**TRANSMITTAL OF THE ENGINEERING EVALUATION/COST ANALYSIS FOR THE
SOILS OPERABLE UNIT INACTIVE FACILITIES AT THE PADUCAH GASEOUS
DIFFUSION PLANT, PADUCAH, KENTUCKY (DOE/LX/07-0016&D2)**

Enclosed for your review is the certified D2 version of the *Engineering Evaluation/Cost Analysis for the Soils Operable Unit Inactive Facilities at the Paducah Gaseous Diffusion Plant, Paducah, Kentucky* (DOE/LX/07-0016&D2). Also enclosed is an associated Comment Response Summary in response to your comments on the D1 version of the Engineering Evaluation/Cost Analysis (EE/CA) for the Soils Operable Unit Inactive Facilities.

1. Certification
2. D2 EE/CA for the Soils Operable Unit Inactive Facilities
3. Comment Response Summary to the D1 EE/CA for the Soils Operable Unit Inactive Facilities

Figure 7. Soil, Sludge, and Water Sampling at SWMU 40

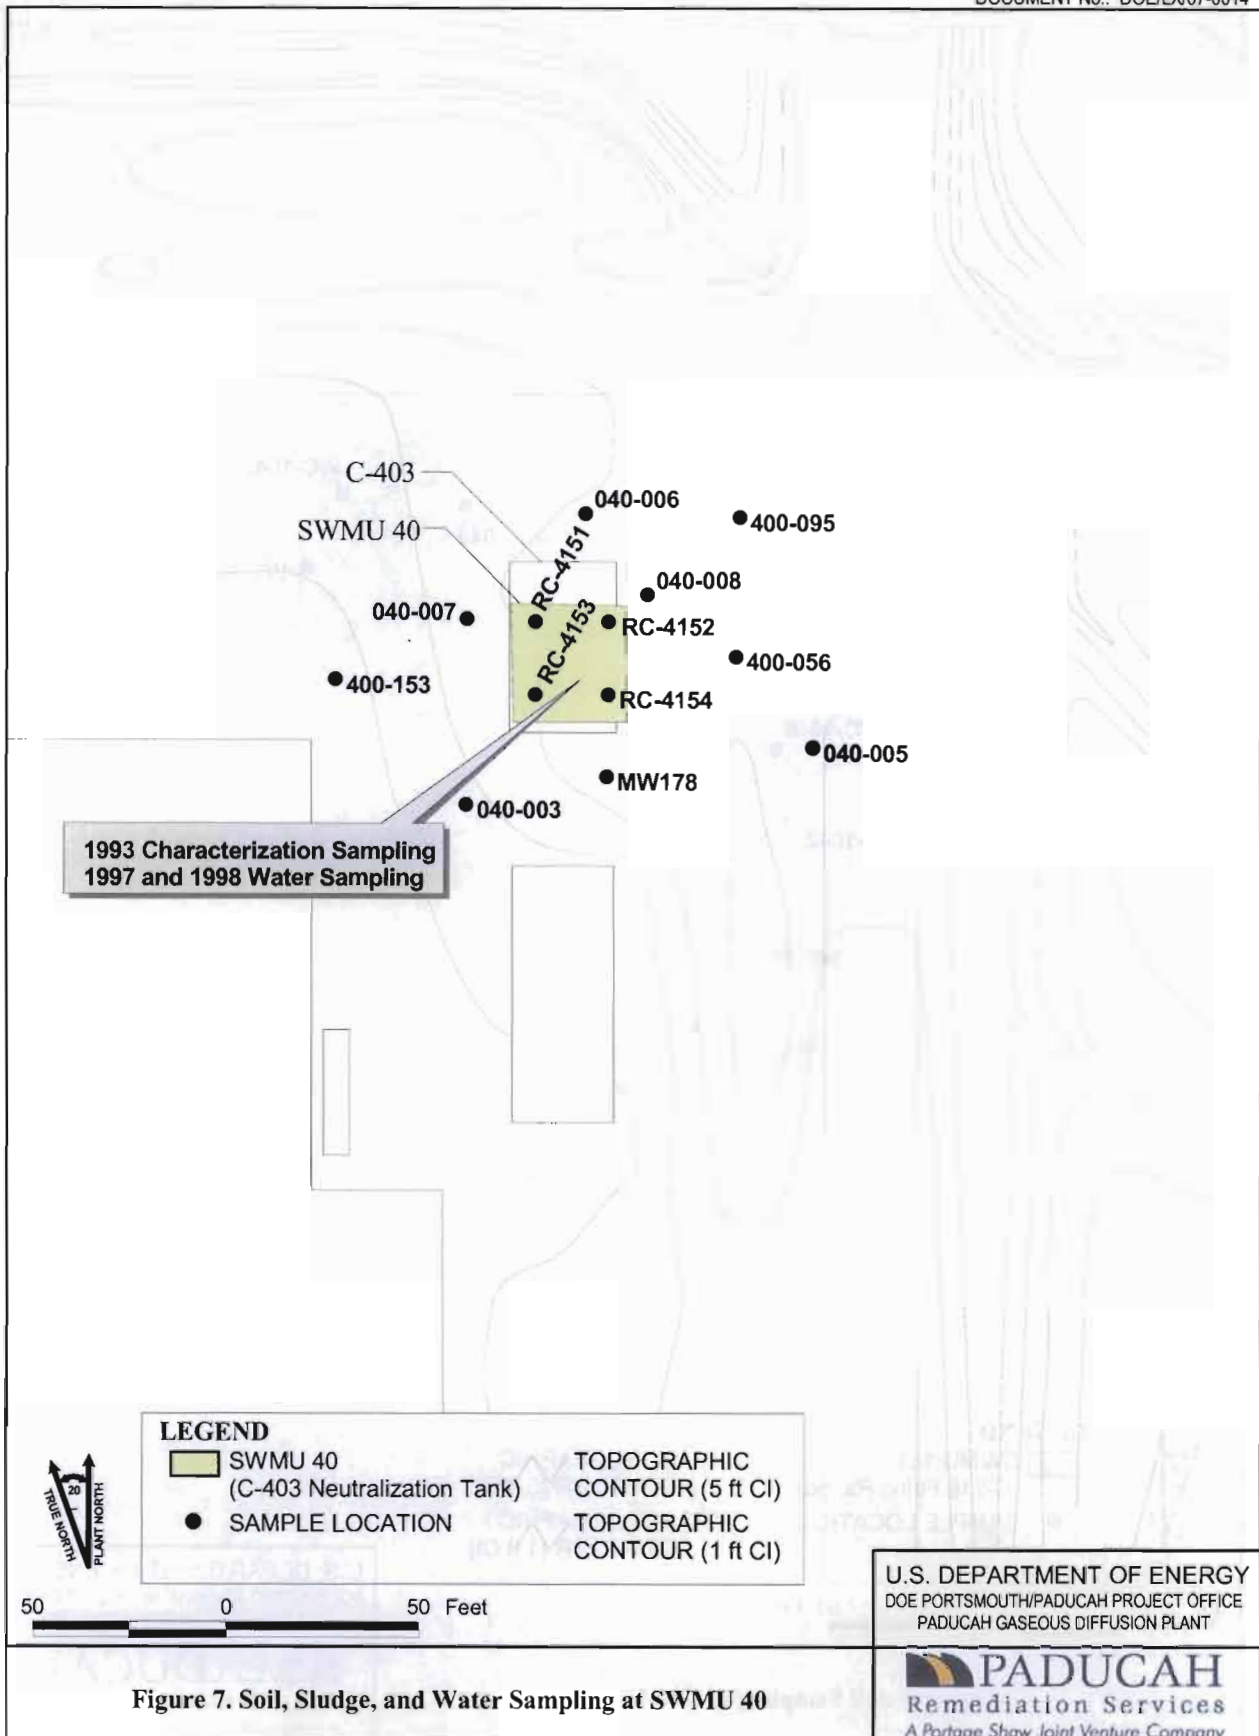
4.	Section 1.5.2 Page 19	C-403 Neutralization Tank (SWMU 40). The section indicates that sediment samples were collected from the tank, but these locations are not plotted on Figure 7. The text also discusses the high concentrations of TCE detected in sediment (6,700 ug/kg) and water in the tank (21,000 ug/L) and later states that "...TCE is the primary COPC that will be considered in this removal action." However, these concentrations are not reflected in Table 3 - The Selected COPCs for SWMU 40 or any tables in Appendix D or E. All sampling locations should be plotted on the map, sampling results should be included in the tables, and TCE should be retained as a COPC. In the discussion for C-403 of the nature, source, and extent of contamination, there is no mention of the radionuclides that are COCs, and confirmed in Table 2 - Np-237 [2 orders of magnitude over it's NAL], and U-235 [4 orders of magnitude over it's NAL]. The radionuclides should be discussed in the text.	The discussion in the text of the high concentrations of TCE detected in sediment and water in the tank are from an unpublished source and the information is referenced in the WAG 6 RI Report. More detail is given regarding these concentrations in the WAG 6 RI Work Plan. These data were collected from within the tank, and, as a result, they were omitted from Figure 7. Figure 7 has been revised to include samples collected from within the tank and the title of the figure has been changed to reflect the addition of these samples. The electronic data available from this 1993 characterization event are included on the CD. The reader has been referenced to the WAG 6 Work Plan instead of the WAG 6 RI Report, with a notation that the information is from an unpublished report to be used only for process knowledge. The following text has been added to the C-403 Neutralization Tank (SWMU 40) discussion: "Other potential contaminants include uranium metal, PCBs, and radionuclides."

Figure 8. Soil, Sediment, and Sludge Sampling at SWMU 19

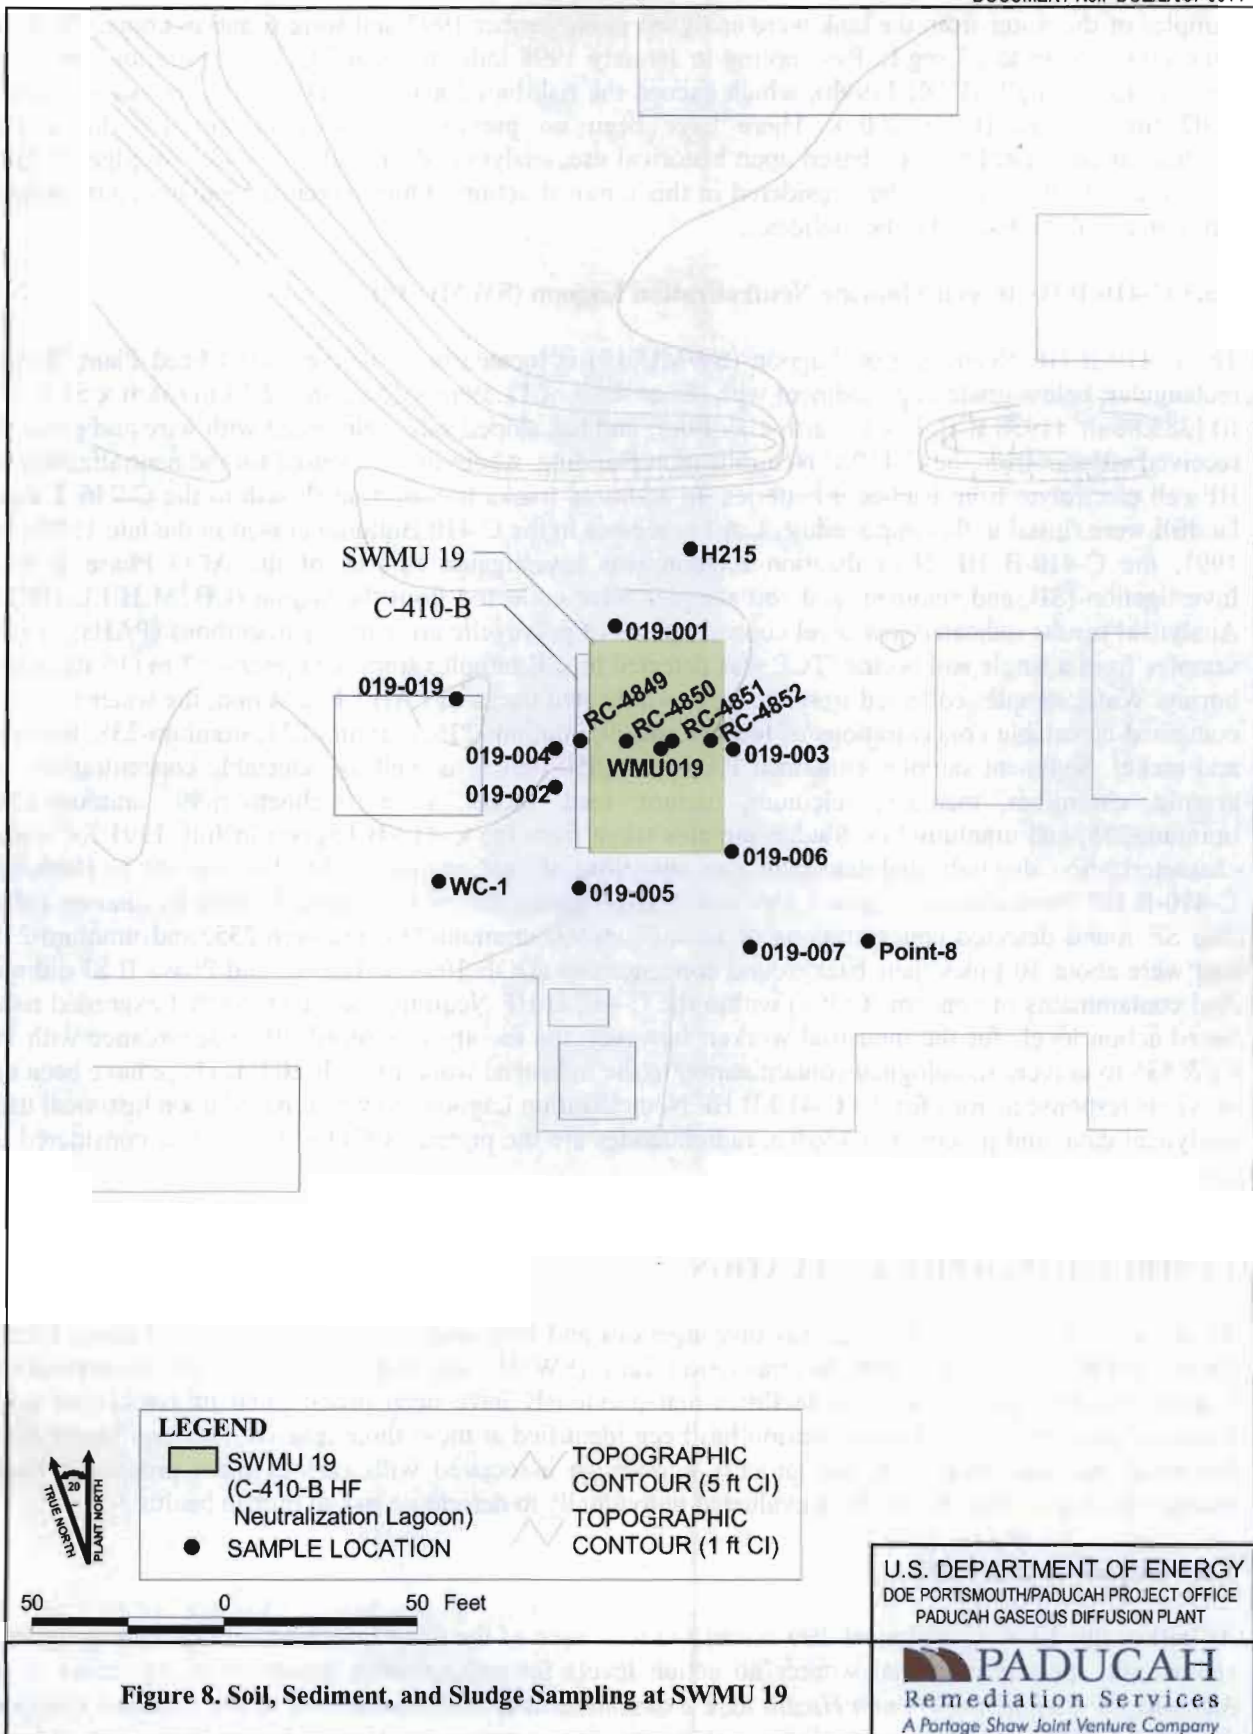
5.	Section 1.5.3 Page 19	C-410-B Hydrogen Fluoride Neutralization Lagoon (SWMU19). The text indicates that sediment and soil samples were collected from the lagoon in 1992. These results are not provided in the tables, nor are the sample locations plotted on Figure 8. The results should be provided.	The sediment and soil samples collected from the lagoon as part of the ACO Phase II Site Investigation are from the locations WMU019 and H215. H215 is included on the figure. WMU019 is listed in Paducah OREIS as a sediment sample and was not included on Figure 8 because the figure shows "Soil Sampling at SWMU 19." The figure title has been revised and WMU019 added. Additionally, RC-4849, RC-4850, RC-4851, and RC-4852, which are listed in Paducah OREIS as sludge samples, have been included on the figure.
